Platform 5
architects

21-102 | Brentwode

Section 73 Planning Statement
March 2025

1.1 Proposal Overview

Approved east elevation

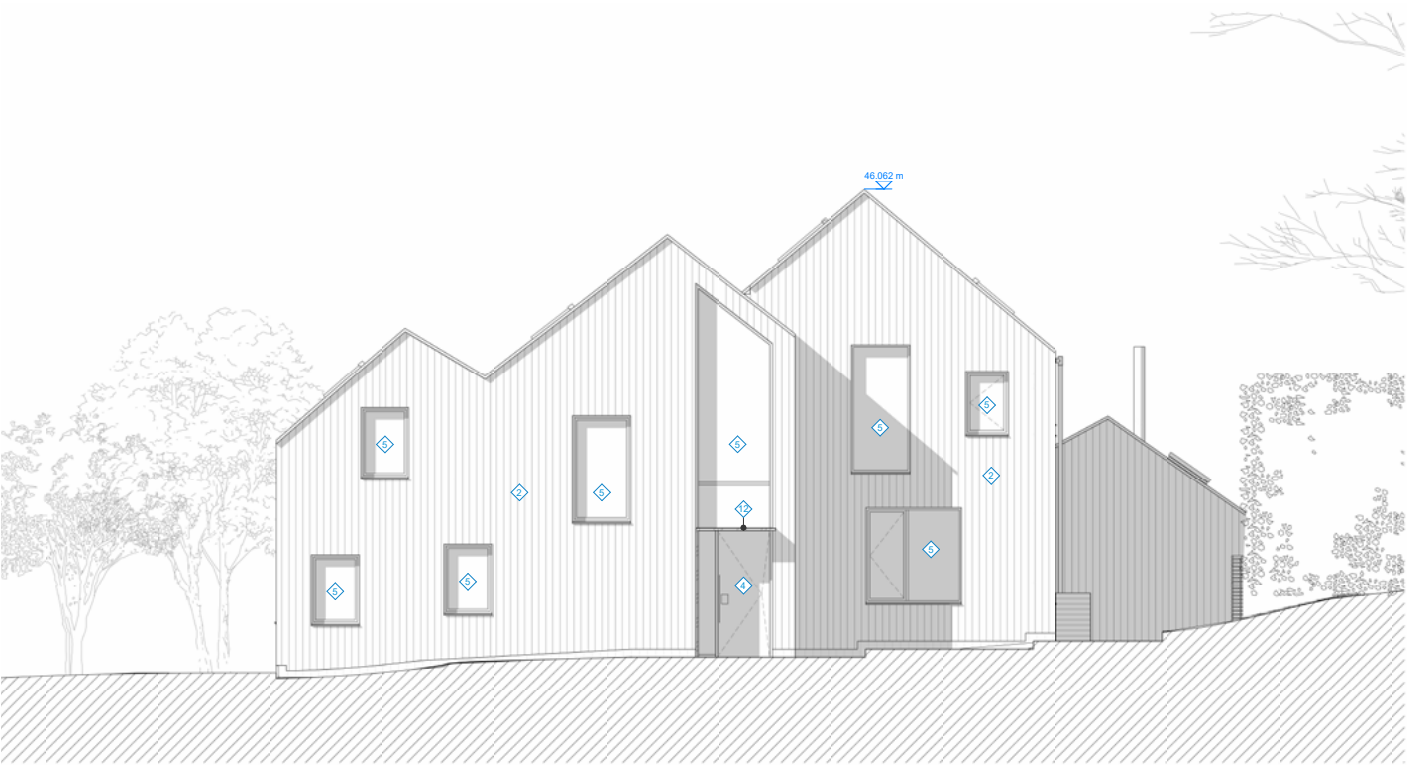
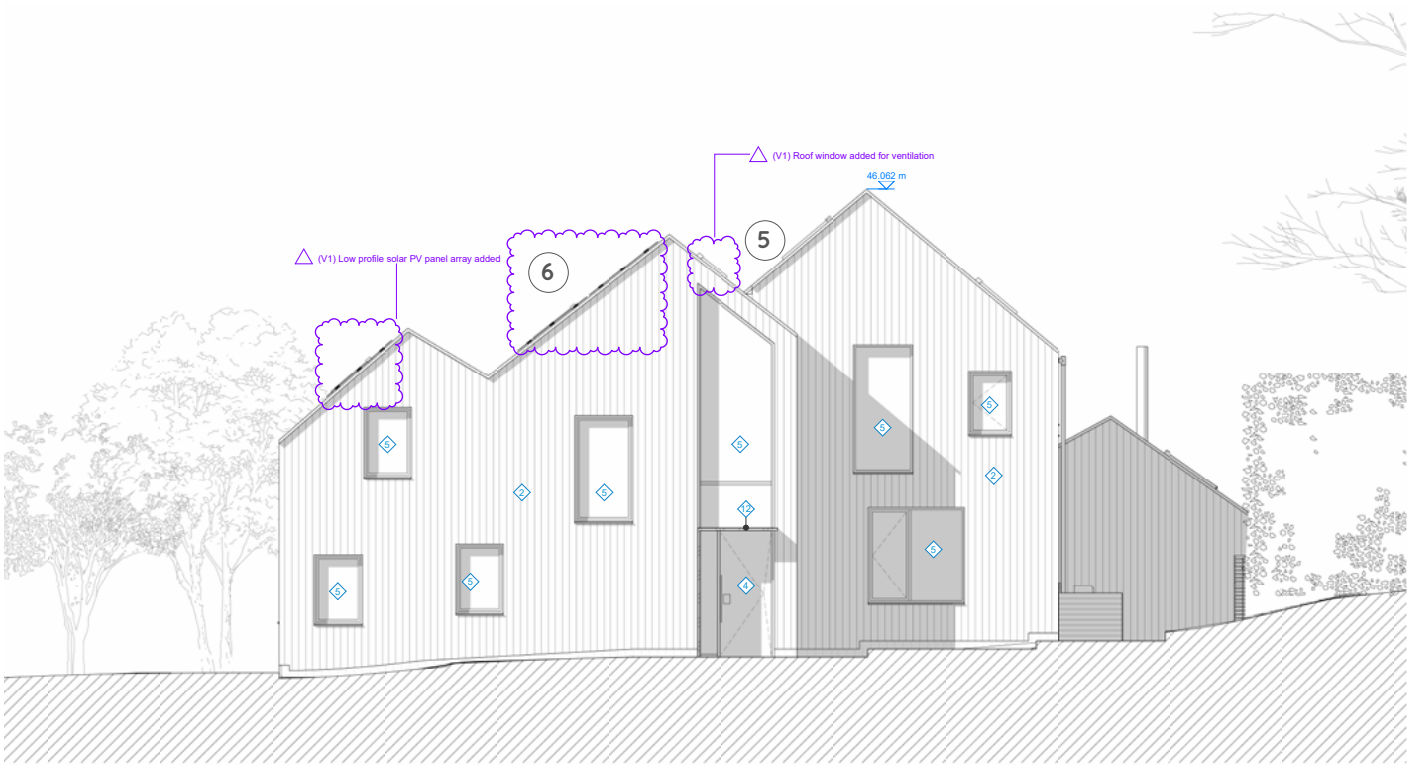
- 1. omission of a north-facing kitchen window
- 2. re-location of the ASHP
- 3. change from a casement glass door with fixed side panel on the south elevation to a sliding glass door
- 4. change in design of the living room rooflight
- 5. addition of an opening roof window above the hallway
- 6. addition of a 25 panel solar photovoltaic array

Approved north elevation

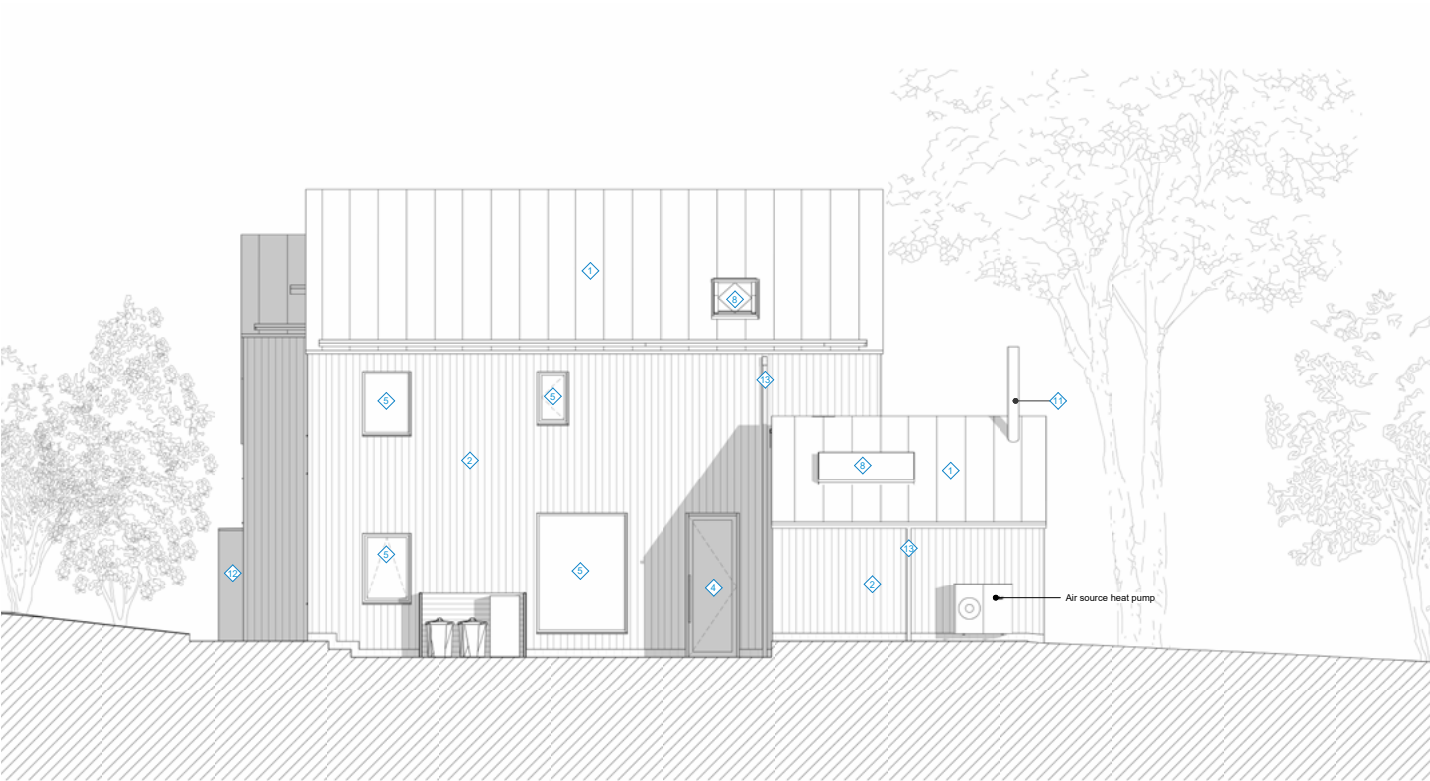
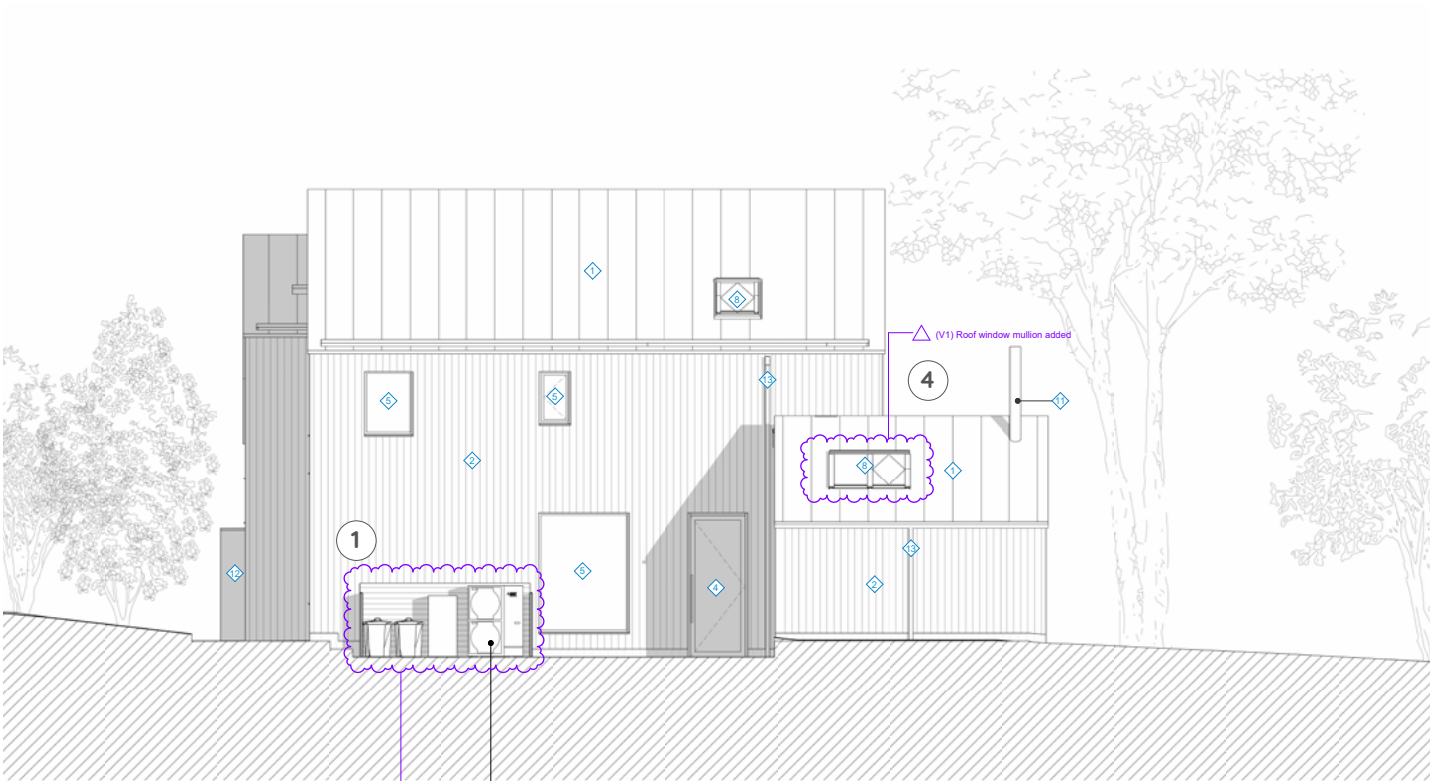
- 1. omission of a north-facing kitchen window
- 2. re-location of the ASHP
- 3. change from a casement glass door with fixed side panel on the south elevation to a sliding glass door
- 4. change in design of the living room rooflight
- 5. addition of an opening roof window above the hallway
- 6. addition of a 25 panel solar photovoltaic array

Approved south elevation

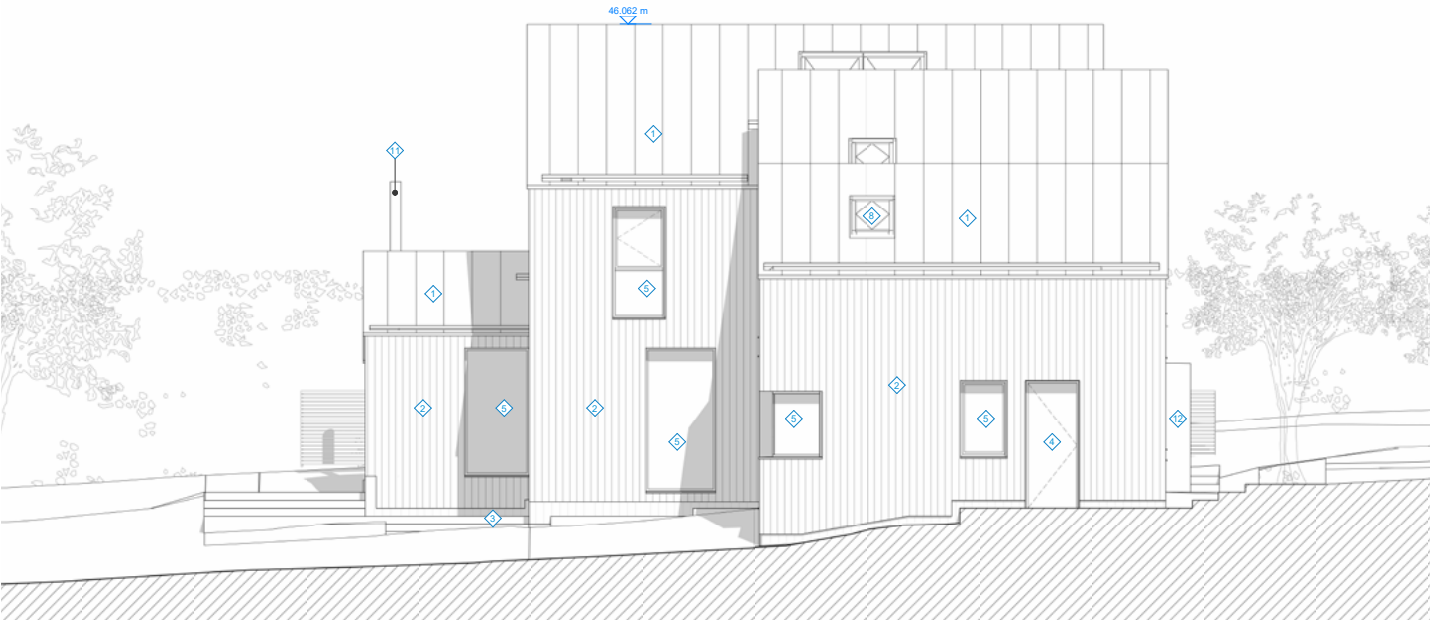
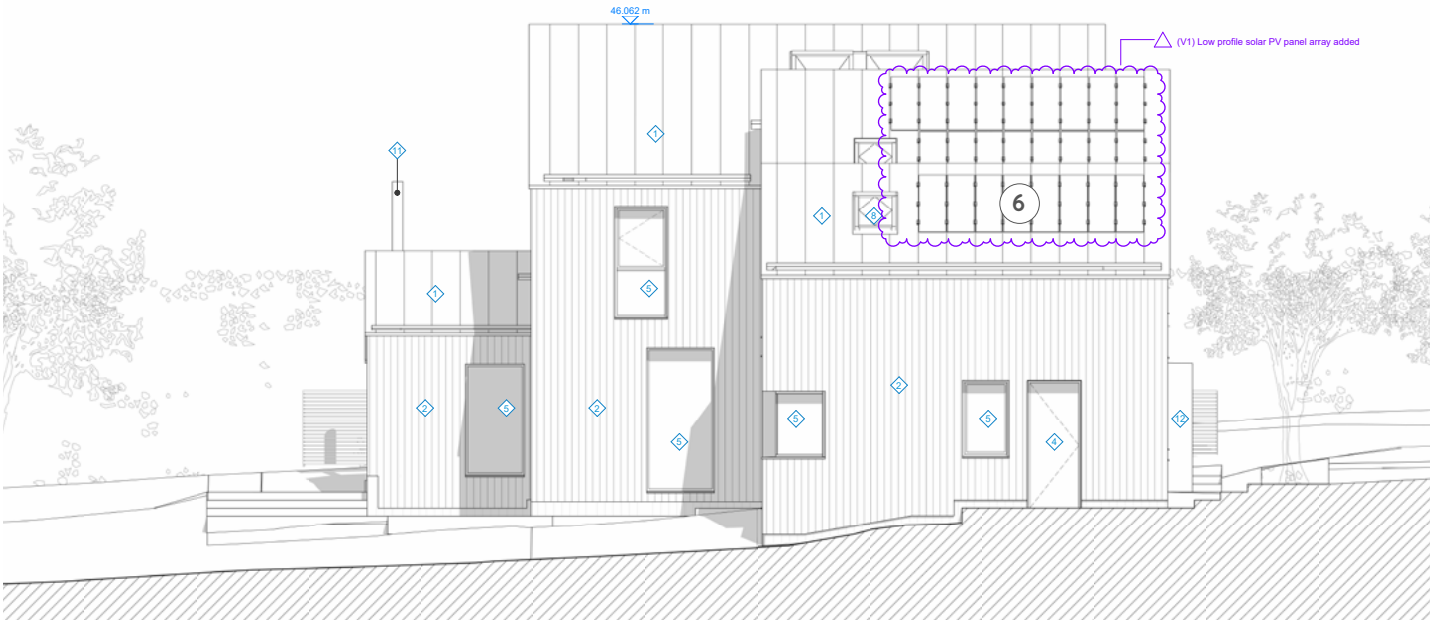
- 1. omission of a north-facing kitchen window
- 2. re-location of the ASHP
- 3. change from a casement glass door with fixed side panel on the south elevation to a sliding glass door
- 4. change in design of the living room rooflight
- 5. addition of an opening roof window above the hallway
- 6. addition of a 25 panel solar photovoltaic array

Approved west elevation

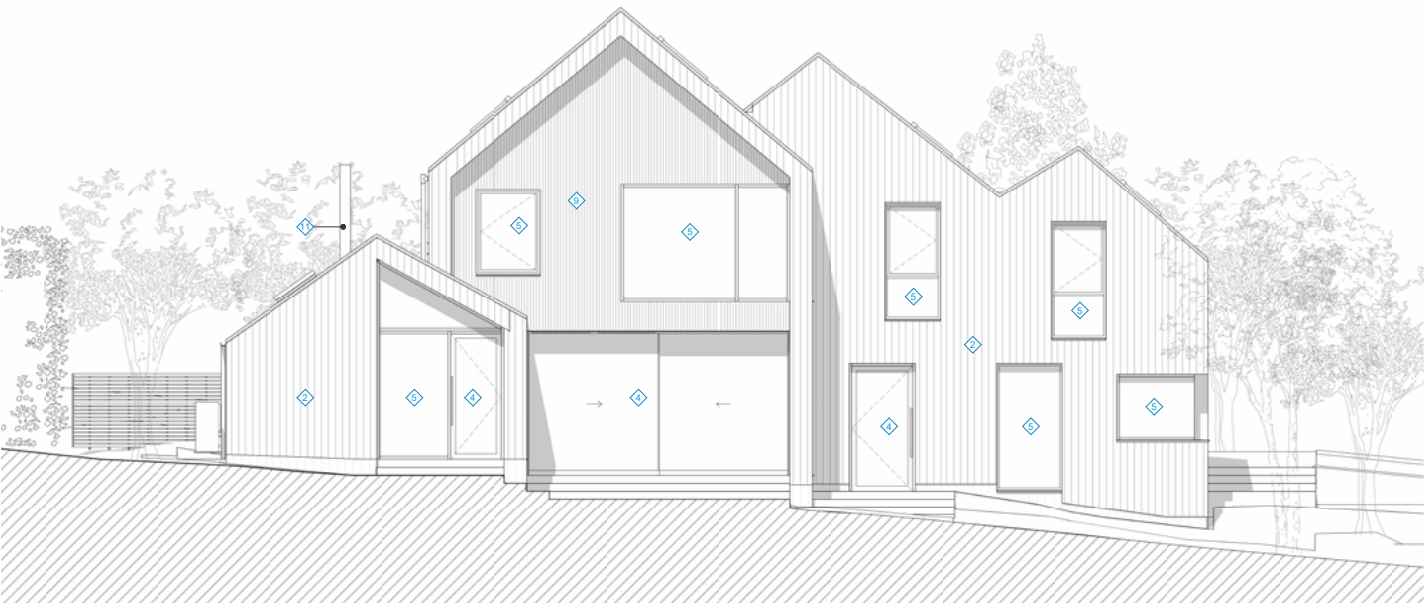
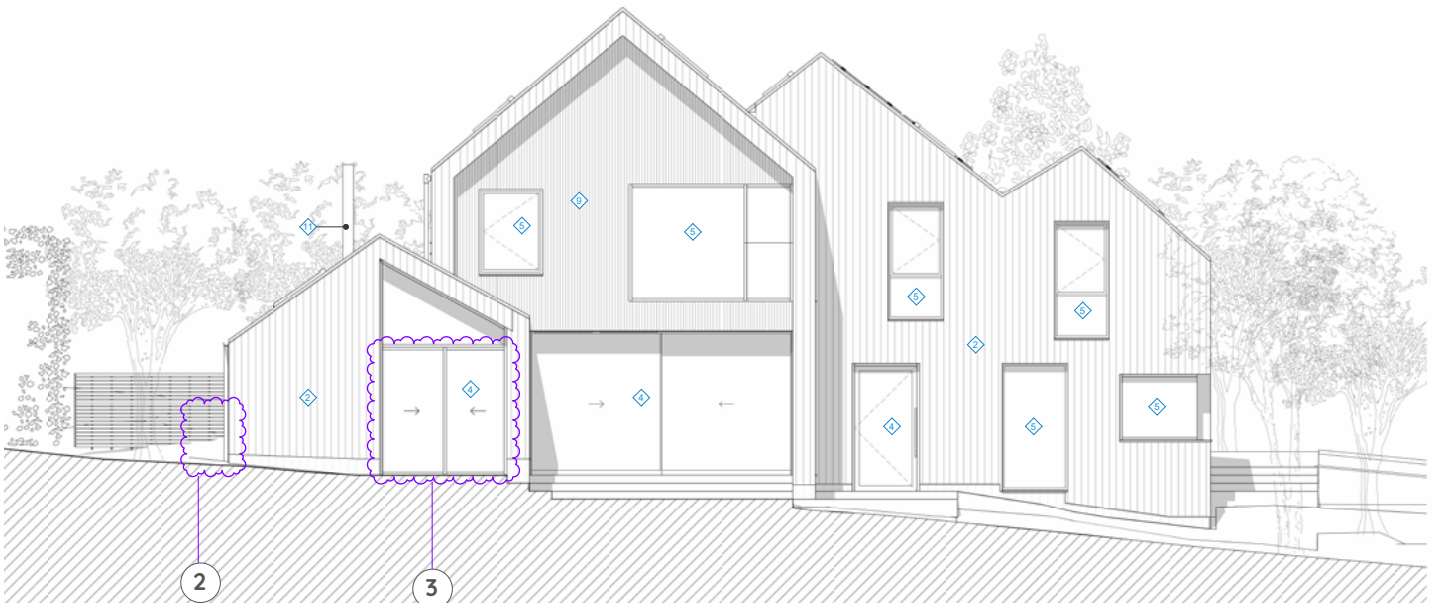
- 1. omission of a north-facing kitchen window
- 2. re-location of the ASHP
- 3. change from a casement glass door with fixed side panel on the south elevation to a sliding glass door
- 4. change in design of the living room rooflight
- 5. addition of an opening roof window above the hallway
- 6. addition of a 25 panel solar photovoltaic array

Overview with solar panels on main house roof

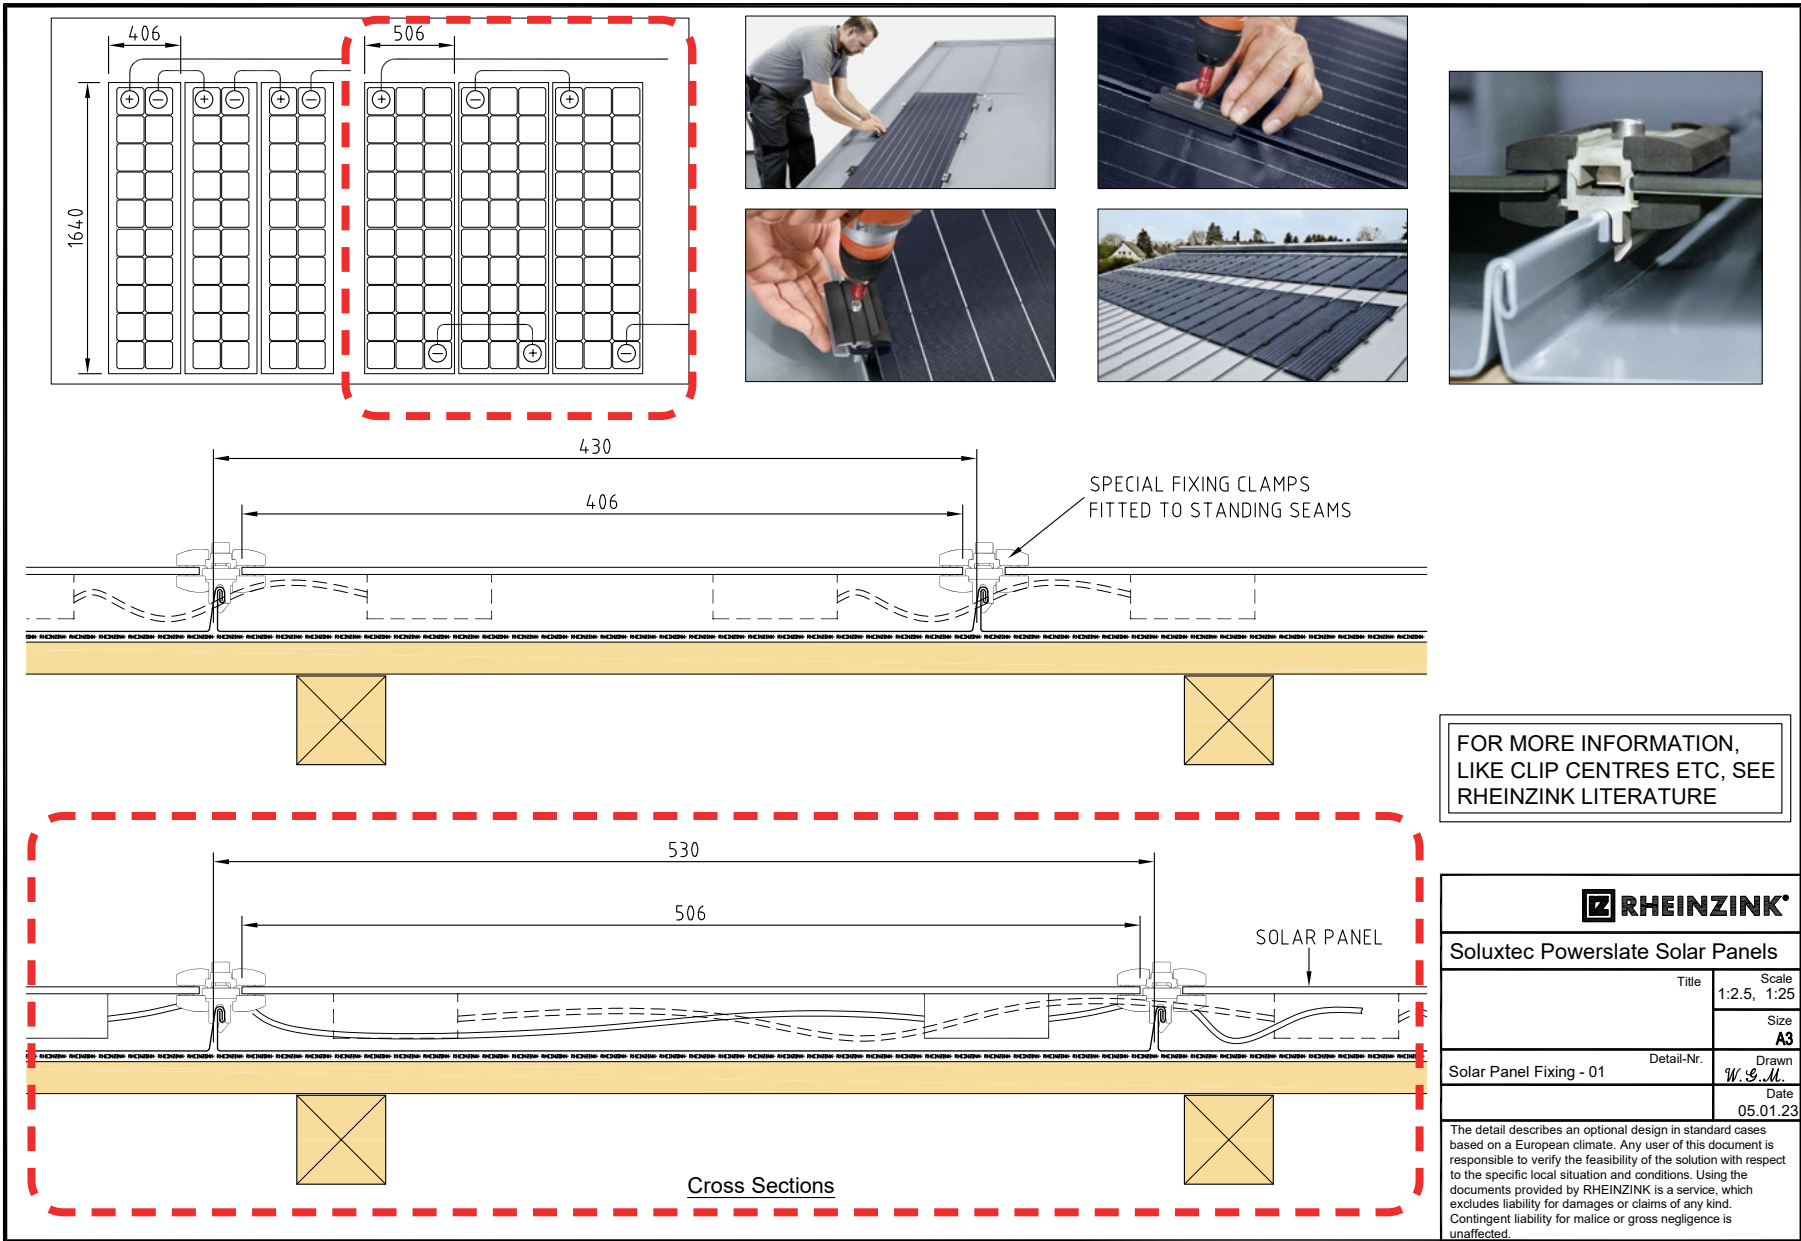
The array will consist of 25no, 1640x506mm Rheinzink FL30 150W panels, arranged in three rows on the south facing roof pitches for a 3.75kWp output. These roofs are ideally orientated for solar PV.

The panels are specifically designed for installation on standing seam roofs, sitting within the 530mm bays of the metal material and being fixed on specialist clips to project only 40mm from the finished roof (max. 55mm for the top of the clips).

Due to the low profile, the panels will have no impact on views from the east or west of the house. The panels will be glimpsed in long views from the south, but are largely screened by hedgerows and they are as well designed as is currently possible with this technology.
